REDLANDS SUBDIVISION, PHASE 3

APPLICATION NUMBER 6 DATE November 1, 2018

REQUEST Subdivision

DETAIL SITE PLAN

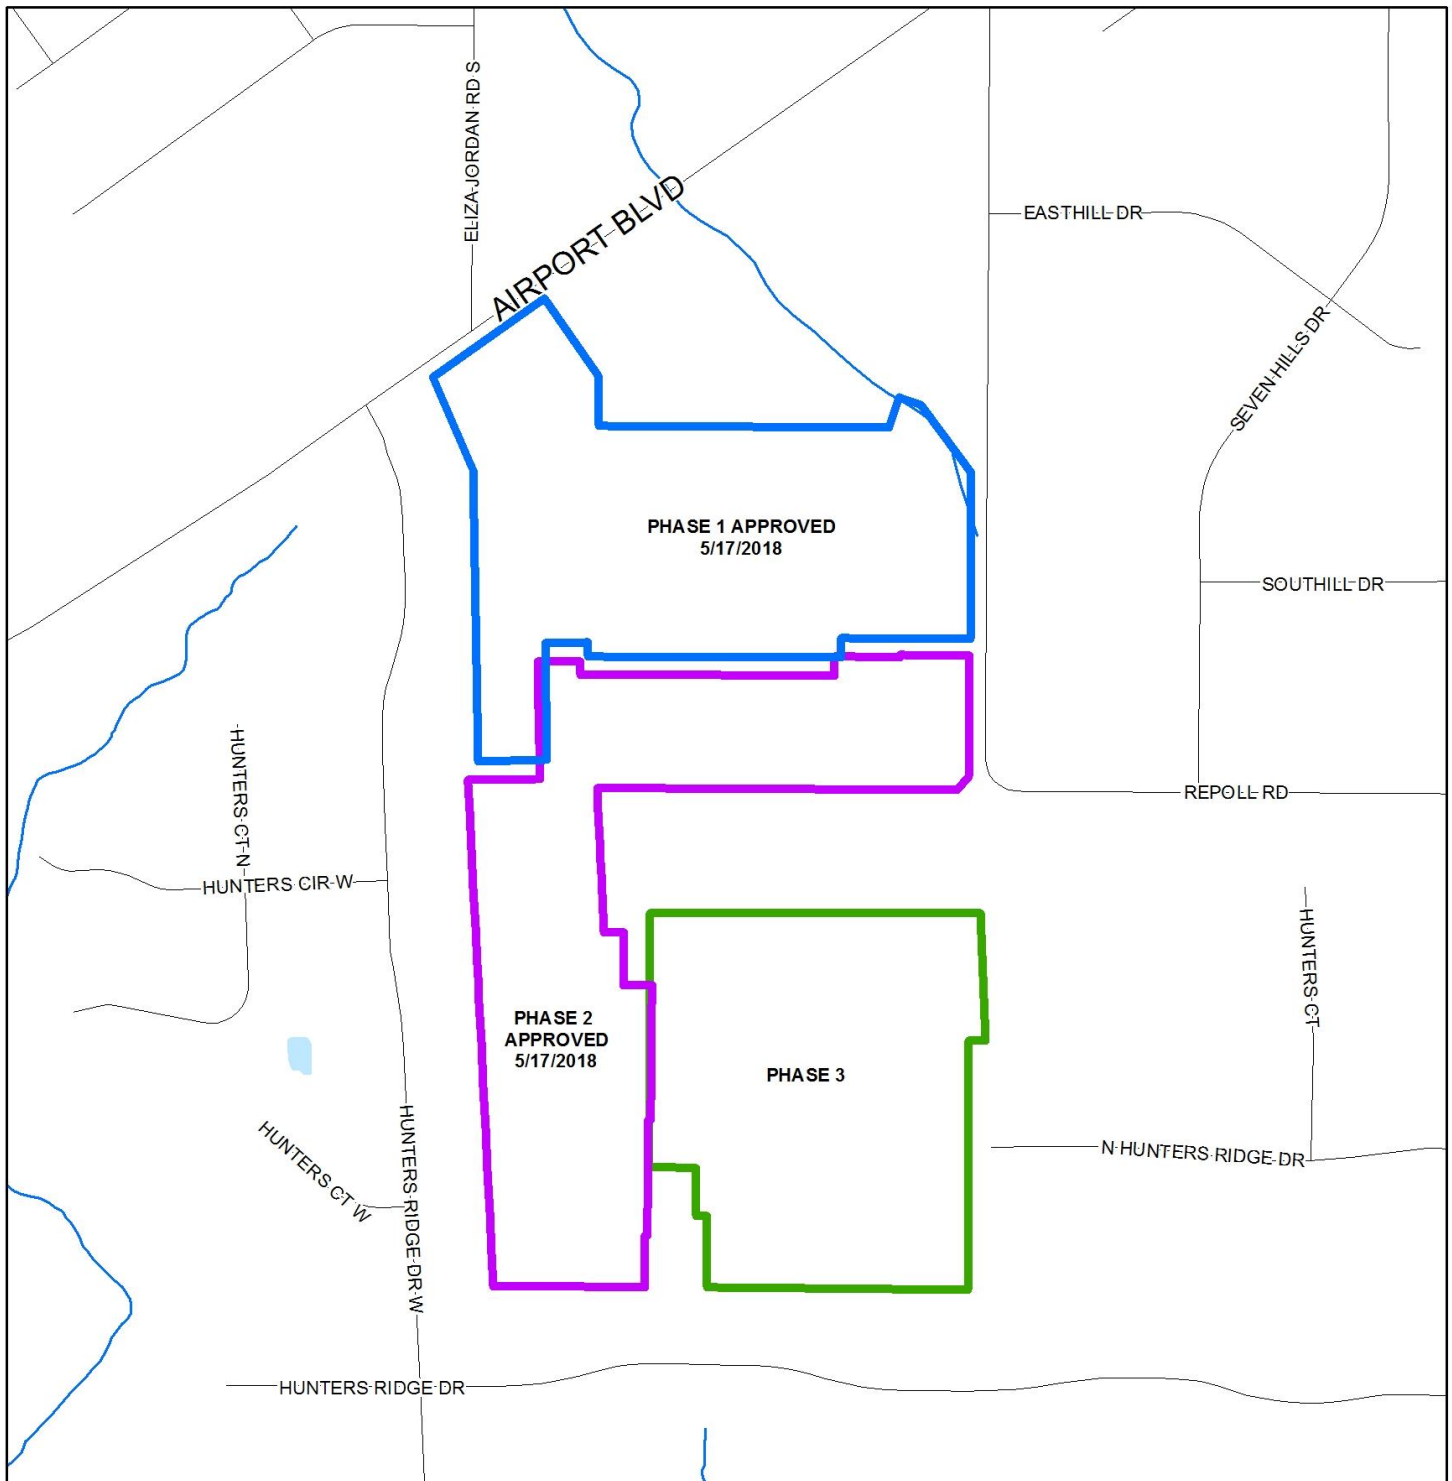
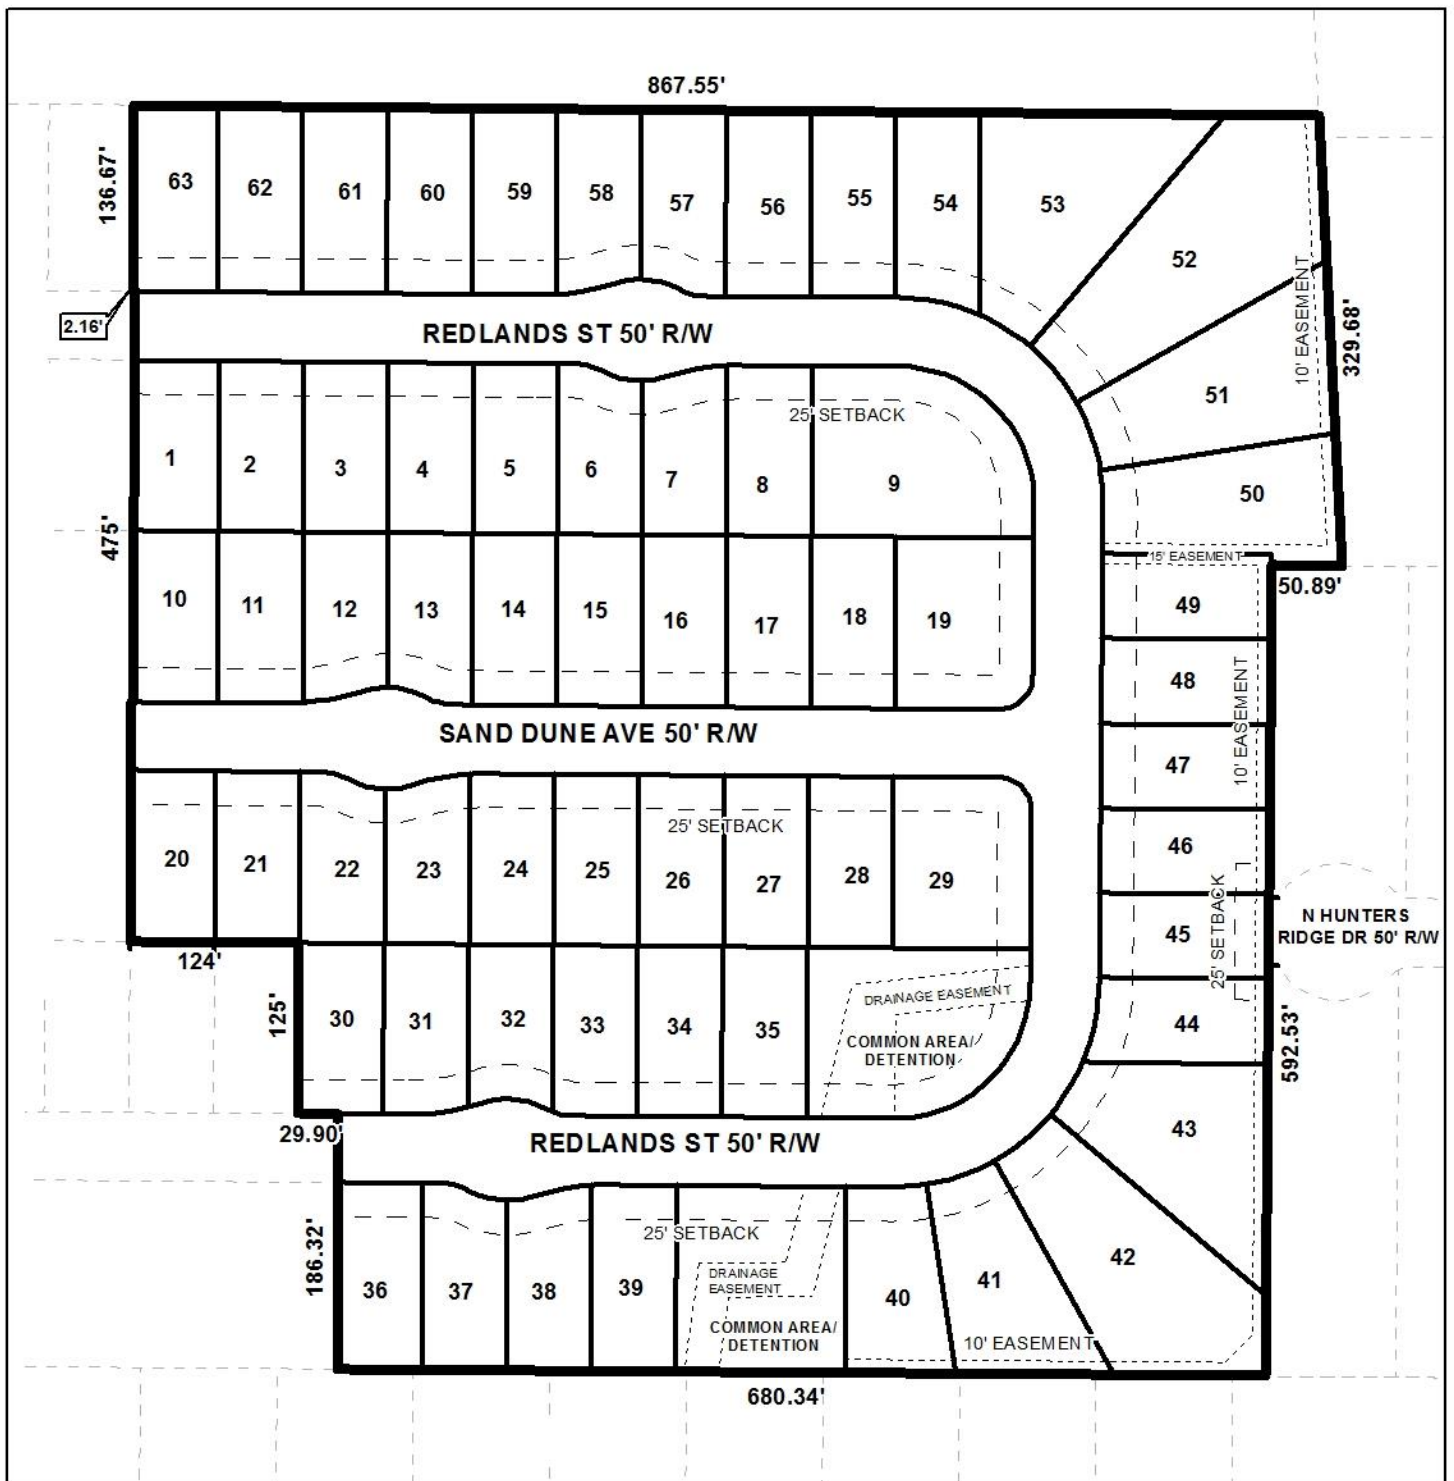
The site has frontage along Redland Street and Sand Dune Avenue, two proposed streets which connect to Phase 2. Lots 44 - 46 also have frontage along North Hunter's Ridge Drive; however a note should be placed on the plat stating Lots 44 - 46 will be denied access to North Hunter's Ridge Drive.

The lot sizes are not labeled in square feet and acres. It appears, however, that all lots will be at least 7,200 square feet, and will be at least 60 feet in width at the minimum building setback line.

If approved, the plat should be revised to depict all lots in both square feet and acres, or the provision of a chart depicting that information will be required.

As mentioned, two common areas/ detention ponds are depicted on the preliminary plat. A note should be placed on the Final Plat stating that maintenance of the common areas are the responsibility of the subdivision's property owners, and not Mobile County.

There are several drainage easements within the site, a note should be placed on the Final Plat stating no structures shall be constructed within any easements.

It should be pointed out that the adjacent lots that are depicted on the preliminary plat, which appear to be a part of the Redlands Subdivision, Phase 2 development, are labeled incorrectly. The Phase 3 plat depicts Lot 52 twice and lots 45, 44, 38, and the common area do not reflect the labeling of the lot numbers as previously submitted and approved on the Redlands Subdivision, Phase 2. The Redlands Subdivision, Phase 3 plat should be revised to reflect the correct and corresponding lots as approved in Phase 2.

1. revision of the plat to correct the labeling of the adjacent subdivision lots identified in the Redlands Subdivision, Phase 2 (lot 52 depicted twice and lots 45, 44, 38, and the common area)

4. revision of plat to depict the lot sizes in square feet and acres, or the provision of a chart depicting that information;
5. retention of the 25' minimum building setback lines;

6. placement of a note on the Final Plat stating each lot and the two common areas are limited to one curb-cut each to the streets internal to the development, and Lots 44-46 are denied direct access to North Hunter's Ridge Drive. The size, design and location of all curb-cuts to be approved by County Engineering and comply with AASHTO standards;

8. placement of a note on the Final Plat stating that maintenance of the common areas are the responsibility of the subdivision's property owners, and not Mobile County;

9. placement of a note on the Final Plat stating no structures shall be constructed within any easements;
10. compliance with Engineering comments: *"Must comply with the Mobile County Flood Damage Prevention Ordinance. Development shall be designed to comply with the storm water detention and drainage facility requirements of the City of Mobile storm water and flood control ordinances, and requiring submission of certification from a licensed engineer certifying that the design complies with the storm water detention and drainage facility requirements of the City of Mobile storm water and flood control ordinances prior to the issuance of any permits. New public roads shall be constructed and paved to standards for County Maintenance, and accepted by Mobile County, while new private roads shall be constructed and paved to minimum County or Subdivision Regulation standards, whichever are greater."* and
